Land at Bird in Eye Farm
South of Bird in Eye Hill
Uckfield

PROOF OF EVIDENCE

Re: TRANSPORT MATTERS

Road Safety Audit Report

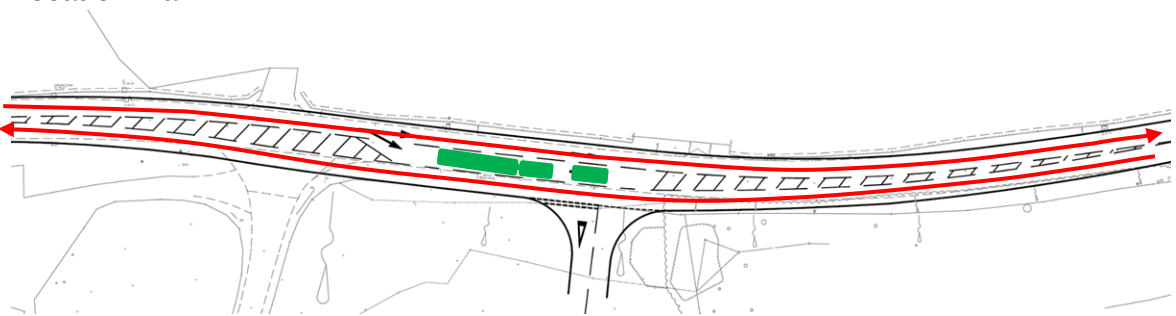
A.1	LOCAL ALIGNMENT
A.1.1	PROBLEM
Location:	Bird in Eye Hill
Summary:	Proposed westbound entry taper does not allow for a smooth alignment
Acc Type:	Sideswipe loss of control type collision
<p>The B2102 Bird in Eye Hill accommodates a series of bends and is currently derestricted, therefore subject to a 60mph speed limit. The Audit Brief includes a summary of a traffic survey that was undertaken in proximity which identifies that 85th percentile approach speeds equate to 42.4mph in an eastbound direction and 45.9mph in a westbound direction. The proposals include the provision of a 3.0 metre wide right turn lane that is to serve a proposed priority access off the southern side of the carriageway. In order to provide the right turn lane, the carriageway is to be widened on both sides; marginally to the north and by 2.75 metres to the south. The scheme drawing illustrates that the westbound road centreline to the east is to follow a taper that is 75 metres long equating to 1 in 25, however, the taper does not appear to follow the edge of carriageway or generate a smooth alignment for westbound traffic. The abrupt change in direction could lead to traffic taking the desire line and encroaching the proposed right turn lane, resulting in sideswipe or loss of control type collisions.</p>

RECOMMENDATION:	
It is recommended that the taper is amended to allow a smooth alignment.	
Location Plan: 	
DESIGN ORGANISATION RESPONSE provided by Bellamy Roberts on the 7 th August '23 following formal issue of this Stage 1 Road Safety Audit on the 31 st July '23	
Agree – This matter will be addressed at the detailed design stage and will not impact on the 2.75m through lane width proposed at this location.

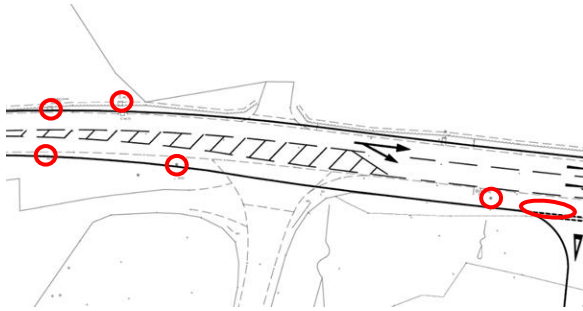
A.2.2	PROBLEM
Location:	B2102 Bird in Eye Hill
Summary:	Existing road gullies will be within the path of vehicles
Acc Type:	Vehicle loss of control
<p>Bird in Eye Hill is cambered forcing surface water to fall to the channels either side of the carriageway where soft verges and a series of road gullies, some of which are offline and situated within a cut-out in the verge, are located. During the site visit associated with this Audit, a number of gullies in proximity to the proposed works were observed to be blocked, although no ponding was observed. The proposals introduce a right turn lane by widening both sides of the carriageway where gullies are present. No details of the proposed surface water drainage have been provided at this stage. A road gully within the path of a vehicle, particularly for two wheeled vehicles, could lead to a loss of control type collision as would ponding as a result of an insufficient surface water drainage network.</p>

RECOMMENDATION:	
It is recommended that the existing gullies are removed, and an adequate surface water drainage network is provided.	
<p>Location Plan: (NB: Not all items are illustrated on the image below)</p>  <p>The location plan on the left shows a road layout with four red circles indicating the locations of gullies. To the right are two photographs: the first shows a grassy verge next to a road, and the second shows a close-up of a gully with a metal grate partially blocked by debris.</p>	
<p>DESIGN ORGANISATION RESPONSE provided by Bellamy Roberts on the 7th August '23 following formal issue of this Stage 1 Road Safety Audit on the 31st July '23</p>	
<p>Agree - All existing gullies will be assessed during the detailed design stage and relocated accordingly.</p>

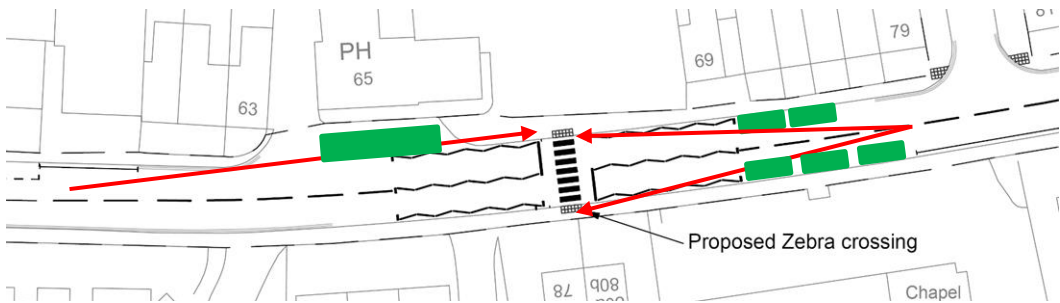
A.2.3	PROBLEM
Location:	Bird in Eye Hill
Summary:	Existing utility covers and telegraph / electric poles are present
Acc Type:	Loss of control type collision
<p>The B2102, Bird in Eye Hill accommodates a number of utility covers and poles in the verge both sides of the carriageway. The proposals include highway works to provide a right turn lane through widening of the existing carriageway on both sides and form a priority access off the southern side of the carriageway. Observations show that a triple utility cover, as well as a number of others, and telegraph / electric poles are present within the area of the works. Retention of the items in their current location will be an obstruction and lead to loss of control type collisions.</p>	
RECOMMENDATION:	
It is recommended that the utility covers and poles are relocated accordingly.	
<p>Location Plan: (NB: Not all items are illustrated on the image below)</p>

<p>DESIGN ORGANISATION RESPONSE provided by Bellamy Roberts on the 7th August '23 following formal issue of this Stage 1 Road Safety Audit on the 31st July '23</p>	
<p>Agree – All existing utility covers and poles will be assessed during the detailed design stage and relocated accordingly.</p>

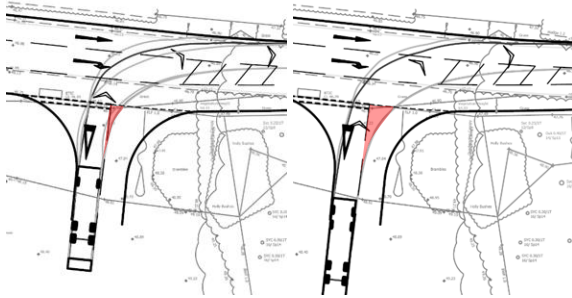
A.2.4	PROBLEM
Location:	B2102 Framfield Road
Summary:	On-street and layby parking may restrict visibility to the proposed crossing
Acc Type:	Vehicle to pedestrian collisions
<p>The B2102 Framfield Road accommodates parking restrictions in places but allows unrestricted parking in others, to include within a layby on the northern side of the carriageway immediately adjacent to The Alma Arms. The proposals include the provision of a zebra crossing adjacent to the access associated with The Alma Arms parking facility just to the east of the existing layby and where the footway on the southern side of the carriageway measures 1.49 metres wide. The scheme drawings illustrate that a full set of zigzags are to be provided either side of the proposed crossing which will prevent on-street parking in the immediate vicinity, however, does not illustrate Belisha Beacons at the proposed zebra crossing at this stage. The Audit Team have concerns that vehicles parked on-street either side of the zigzags, and within the layby to include HGV's servicing the public house, could limit intervisibility between a pedestrian and approaching traffic which may lead to heavy braking and loss of control or vehicle to pedestrian collisions.</p>

RECOMMENDATION:	
It is recommended that adequate visibility to the proposed zebra crossing is achievable.	
Location Plan: 	
DESIGN ORGANISATION RESPONSE provided by Bellamy Roberts on the 7 th August '23 following formal issue of this Stage 1 Road Safety Audit on the 31 st July '23	
<p>Agree - Belisha Beacons will be provided at each end of the crossing, on the nearside closest to approaching traffic, as per Traffic Signs Manual Chapter 6 guidance. These coupled with the associated road markings will ensure that the crossing will be clear to approaching traffic which should approach cautiously as legally required. See drawing 5330/034 Rev. C.</p>	
<p>A speed survey was undertaken along Framfield Road, east of the proposed crossing. This recorded a westbound 85th percentile approach speed of 29.5mph. This equates to a stopping sight distance of 39.5m which can be achieved. See 5330/033 Rev. A.</p>

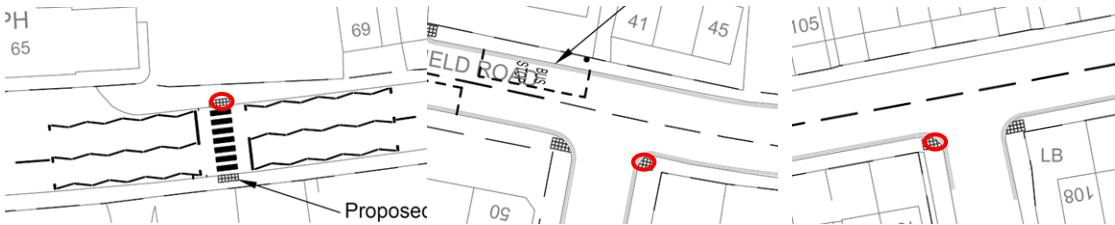
Acc Type: Rear and side impact type collisions

Bird in Eye Hill is a single carriageway two-way road that is derestricted but according to the Audit Brief, observes 85th percentile speeds of 39.9mph and 43.4mph in an east and westbound directions respectively. The proposals include the provision of a right turn lane which, as detailed within the Audit Brief, is based on a design speed of 85kph (53mph). The scheme drawing illustrates that double white road centreline markings are to be provided on the westbound approach and that visibility splays that accord with 85th percentile approach speeds are achievable. Whilst the proposals allow for the majority of the traffic to become aware of the junction ahead, the Audit Team have concerns that vehicles travelling at speeds in excess of the 85th percentile speed, but within the speed limit of the road, will not become aware of the proposed junction at a safe distance.

Agree – this will be included at the detailed design stage.

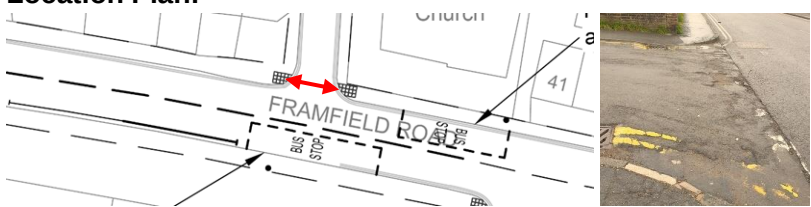
A.4	WALKING CYCLING AND HORSE RIDING
A.4.1	PROBLEM
Location:	Selby Road and Harcourt Road
Summary:	Service covers are present where an uncontrolled crossing point is to be provided
Acc Type:	Pedestrian trip, fall and personal injury and vehicle to pedestrian collisions
<p>The simple priority junctions of Selby Road and Harcourt Road with the B2102 Framfield Road consist of tight corner radii formed with full height conservation kerbs. The proposals include the provision of new uncontrolled crossing points that are in-line with the Framfield Road footway and are to benefit from tactile paving, as is the proposed zebra crossing. Observations show that service covers are present within the footway to the west of Selby Road, east of Harcourt Road and on the northern side of Framfield Road in proximity of the proposed zebra crossing. No standard details have been provided to identify the precise geometry of the proposed crossing points, however, the existing covers will be a trip hazard if not adjusted adequately which could lead to a fall and personal injury. Moreover, the presence of the covers may limit the provision of tactile paving which could lead to a visually impaired pedestrian entering the carriageway unaware of the potential for vehicular traffic and result in a vehicle to pedestrian collision.</p>

RECOMMENDATION:	
It is recommended that the existing covers are adjusted.	
<p>Location Plan:</p> 	
DESIGN ORGANISATION RESPONSE provided by Bellamy Roberts on the 7 th August '23 following formal issue of this Stage 1 Road Safety Audit on the 31 st July '23	
Agree - the existing covers will be adjusted if necessary and will be considered further at the detailed design stage.

CLIENT	Croudance Homes Ltd.		
PROJECT	Bird in Eye, Uckfield		
TITLE	Proposed Access - Right Turn Lane		
DRAWN BY	ARM	DESIGN BY	ARM
DATE	02/02/22	CHK BY	MT
SCALE	1:500 @ A1	DRAWING No.	5330 / 021
		REV No.	M

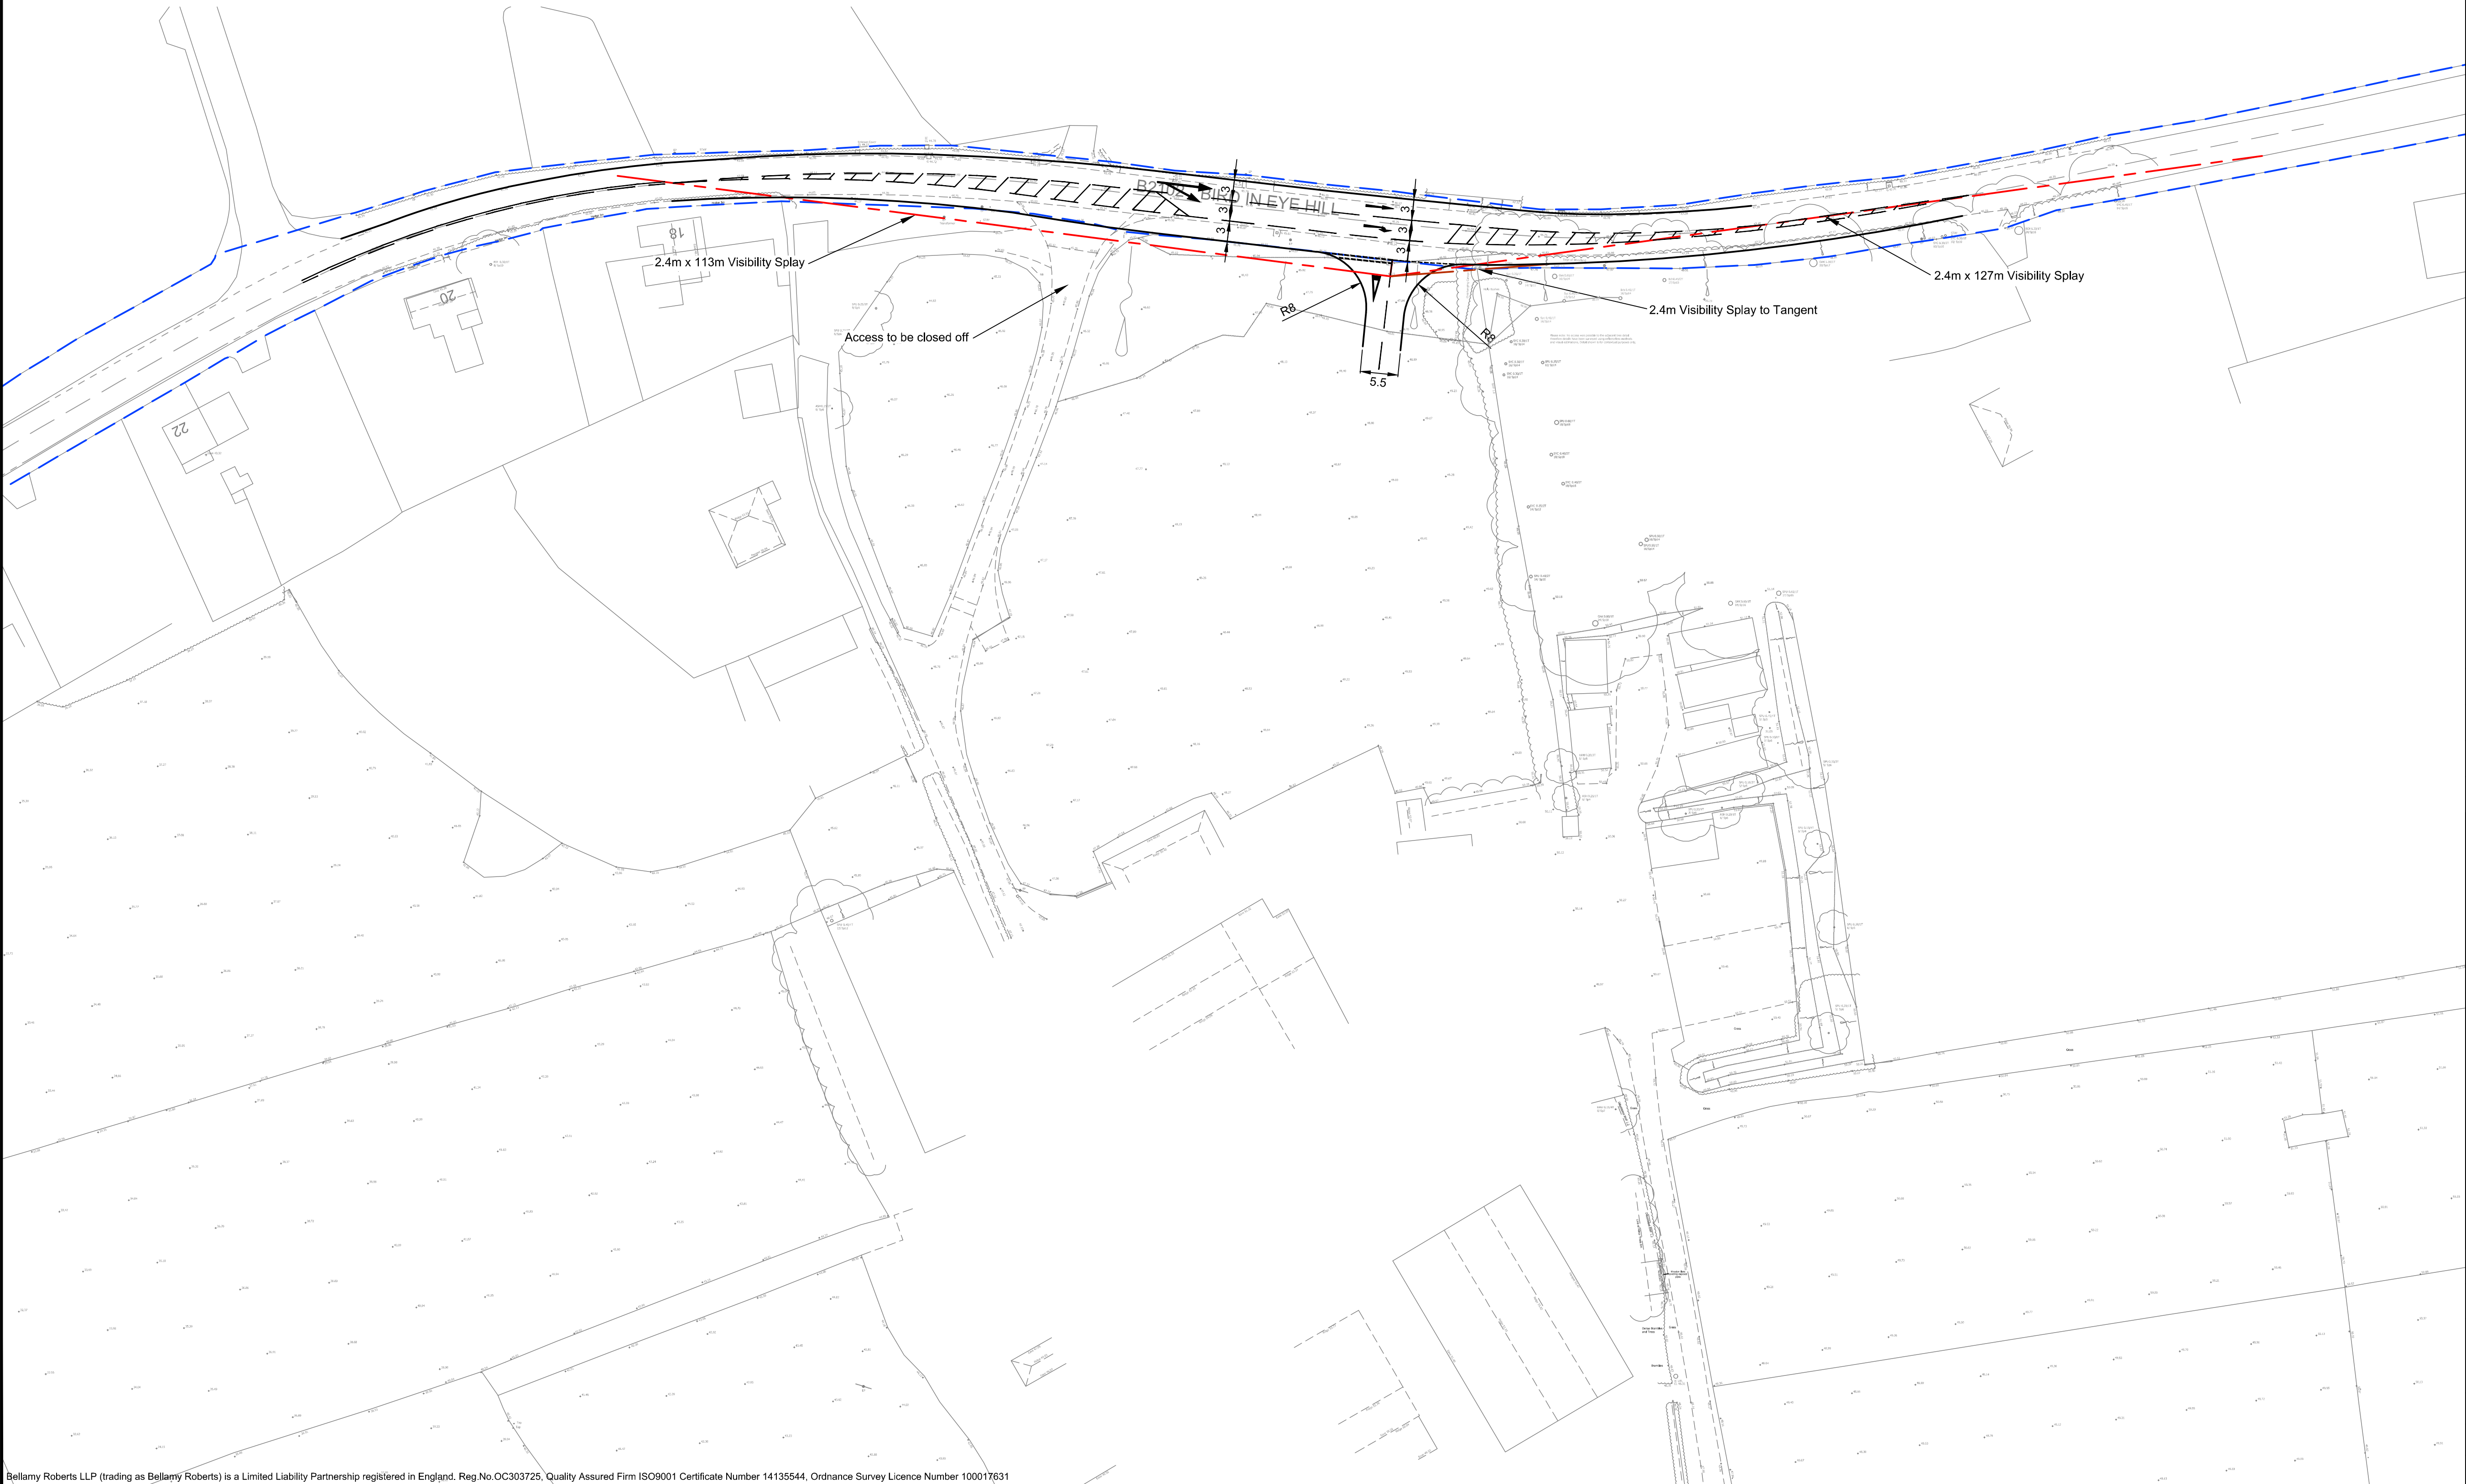
M	Design Revised, running lanes increased to 3m wide	JCB	MT
L	Design Revised	JCB	MT
K	Design Revised	MB	MT
J	Design Revised	MB	MT
H	Design Revised	JCB	MT
G	Taper revised to 1:25 on RTL	JCB	MT
F	AMENDMENT NOTE	JCB	MT
E	AMENDMENT NOTE	JCB	MT
D	AMENDMENT NOTE	JCB	MT
C	AMENDMENT NOTE	ARM	MT
B	AMENDMENT NOTE	ARM	MT
A	AMENDMENT NOTE	ARM	MT
REVISION	AMENDMENT	DRN	CHK

- The road widening on the south side will most likely fall within the root protection zone(s) of the mature trees. Special engineering measures will be necessary to mitigate against the potential for damage to the root system and impact on the structural stability of the trees, or even the removal of the trees may be necessary. (landscape team consulted) in this regard. Are the trees within the public highway or do they belong to a third party? Response from Landscape team suggests that there is likely to be impact on roots of trees on third party land (not on the highway) which is likely to result in some negotiation with the landowners at detailed design stage.

Thank you for your emails. Having reviewed your drawing 5330-021 revision M and 5330-036 revision A, I can confirm that the provision of the proposed 3 metre through lanes either side of a 3 metre right turning lane, addresses the road safety concern raised within item A.2.1 of our Stage 1 Road Safety Audit RSA-23-083.
